**MECKLENBURG COUNTY**
**HEALTH DEPARTMENT**

# APPLICATION FOR A RESIDENTIAL SITE IMPROVEMENT PERMIT/ CONSTRUCTION AUTHORIZATION FOR AN ON-SITE WASTEWATER SYSTEM, NEW WELL INSTALLATION, OR REPAIR OF EXISTING WELL

Re: Application for improvement permit for: 3 Bedroom House
Property Location: 12529 Providence Rd West, Charlotte, NC 28277 (PID 223-031-08)
Health Department File Number: **10604B (App ID 11217)**

# SOIL/SITE EVALUATION for ON-SITE WASTEWATER SYSTEM

## PROPOSED PLOT PLAN

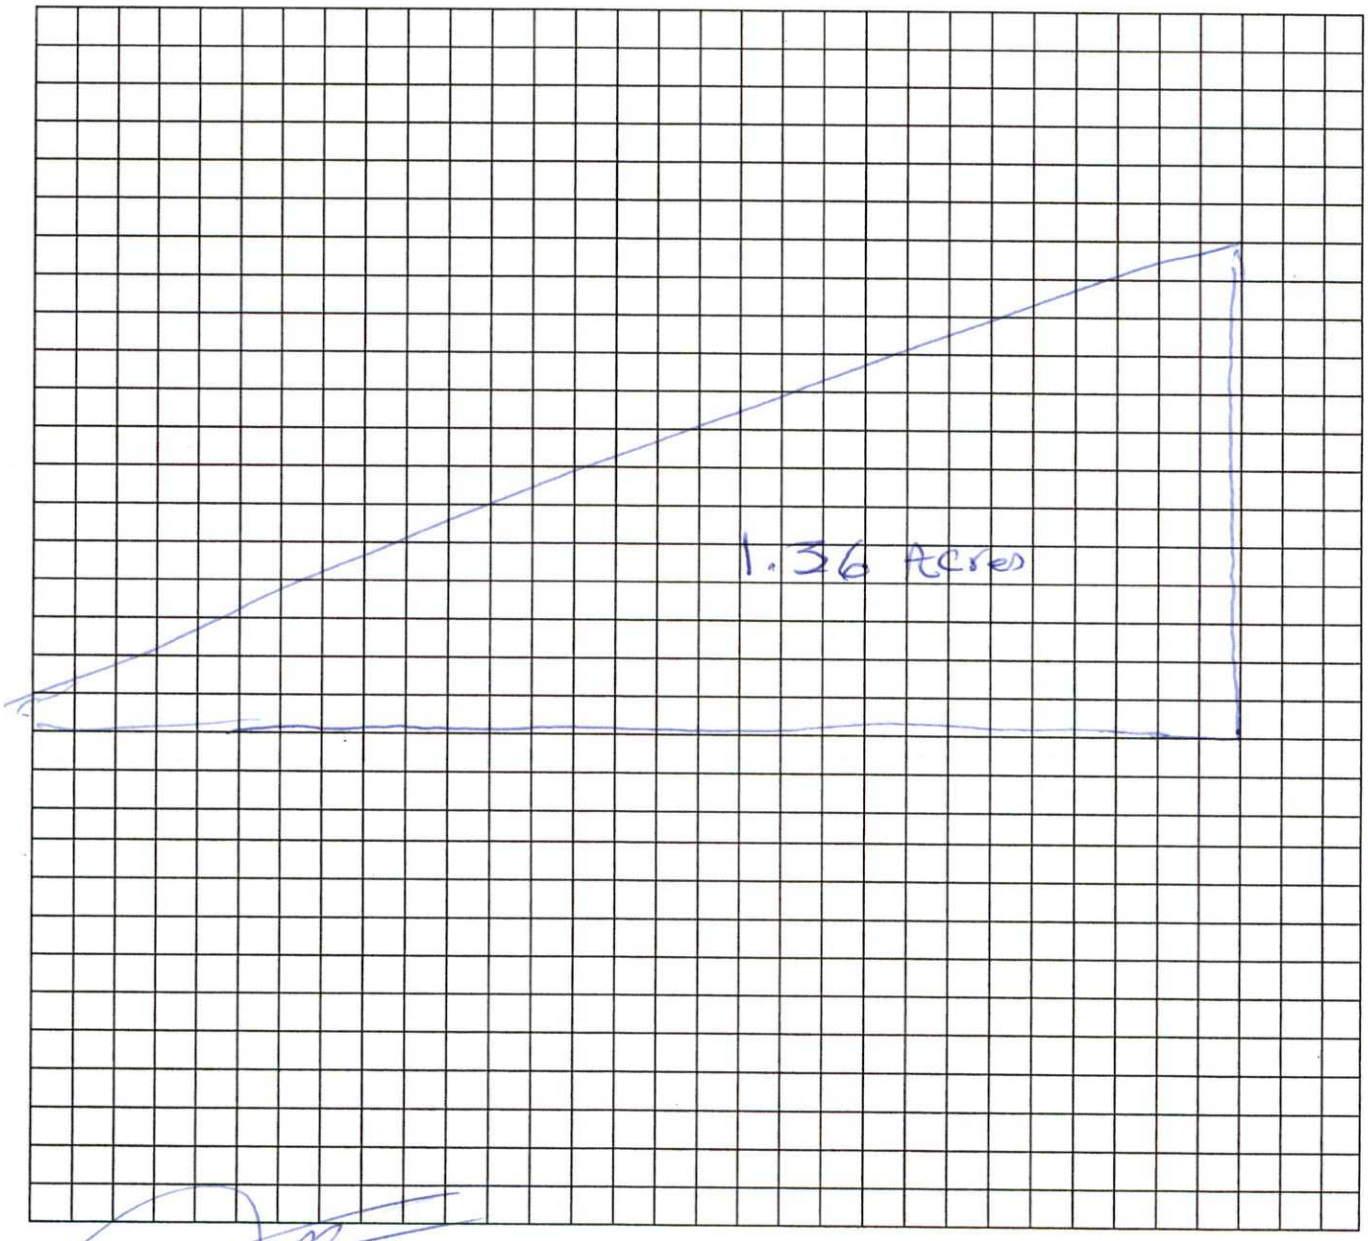
Based on the criteria set out i ...ina Administrative Code, Rules .1940 through .1948, th ...**BLE** for a ground absorption sewage system. T ...t is **DENIED.** A copy of the site evaluation is enclosed

- ☐ Unsu ...Rule .1940)
- ☒ Unsui ...logy) (Rule .1941)
- ☒ Unsui ...
- ☒ Unsui ...epair (Rule .1943)
- ☐ Presence of restrictive horizon (Rule .1944)
- ☒ Insufficient space for septic system and repair area (Rule .1945)
- ☐ Unsuitable for meeting required setbacks (Rule .1950)
- ☐ Other (Rule .1946)

For the reasons set out above, the property is currently classified **UNSUITABLE,** and an improvement permit shall not be issued for this site in accordance with Rule .1948 (c).

However, the site classified as **UNSUITABLE** may be classified as **PROVISIONALLY SUITABLE** if written documentation is provided that meets the requirements of Rule .1948(d). A copy of this rule is enclosed. You may hire a consultant to assist you if you wish to try to develop a plan under which your site could be reclassified as **PROVISIONALLY SUITABLE.**

**Soil Boring Location Sketch**

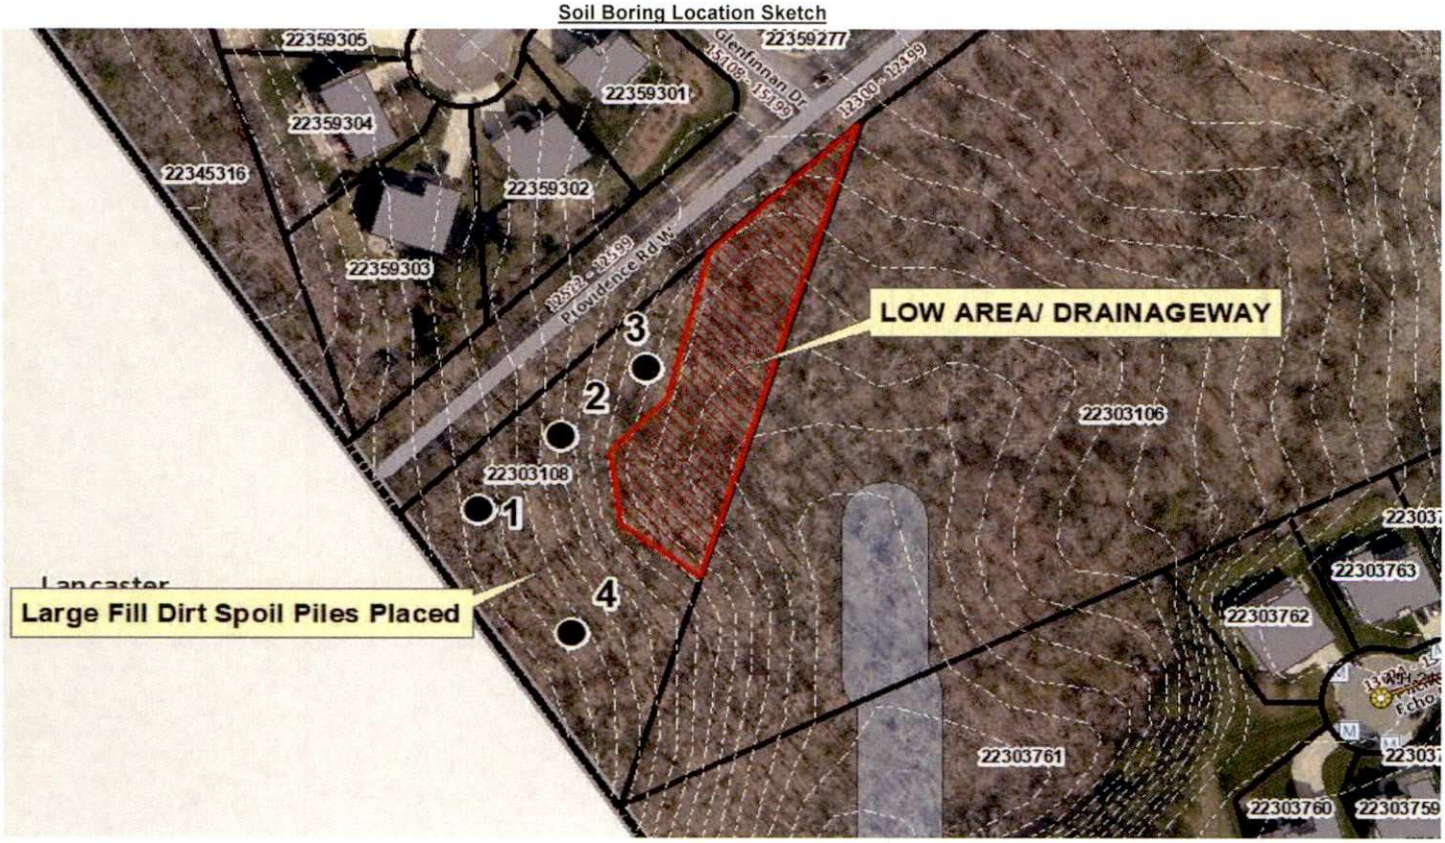
| PROFILE # | .1940 Landscape Position/ Slope% | Horizon Depth (IN.) | SOIL MORPHOLOGY .1941 .1941 Structure/ Texture | .1941 Consistence Mineralogy | b PROFILE FACTORS .1942 Soil Wetness/ Color | .1943 Soil Depth (IN.) | .1956 Sapro Class | .1944 Restr Horiz | General Comments | **Profile Class & LTAR** | **Maximum Trench Bottom Depth for 3' Wide Conventional Trench** |
| Boring #1 | LS 8% | 0 - 14<br>14 - 36 | gr SL<br>mass SCL | SS SP FR SEXP<br>S SP FR SEXP | 10YR 6/1 at 16" | 14 | NA | NA | | **US** | **NA** |
| Boring #2 | LS 13% | 0 - 18 | mass C | S VP VFI EXP | | 18 | NA | NA | Need pit to describe soil >18" | **US** | **NA** |
| Boring #3 | LS 13% | 0 - 6<br>6 - 20 | gr SCL<br>sbk C | SS SP FR SEXP<br>S P FI SEXP | 10YR 7/1 at 14" | 20 | NA | NA | | **US** | **NA** |
| Boring #4 | LS 12% | 0 - 6<br>6 - 16<br>16 - 22 | sbk CL<br>sbk C<br>mass SCL | SS SP FR SEXP<br>S P FR/FI SEXP<br>SS SP FR SEXP | 10YR 7/1 at 17" | 16 | NA | NA | | **US** | **NA** |

Other Factors (.1946): NA
Soil Evaluation By: Jacob Presley, REHS, LSS
Others Present:
Site Classification (.1948): Unsuitable
Site Evaluation By: Jacob Presley, REHS, LSS
Others Present:
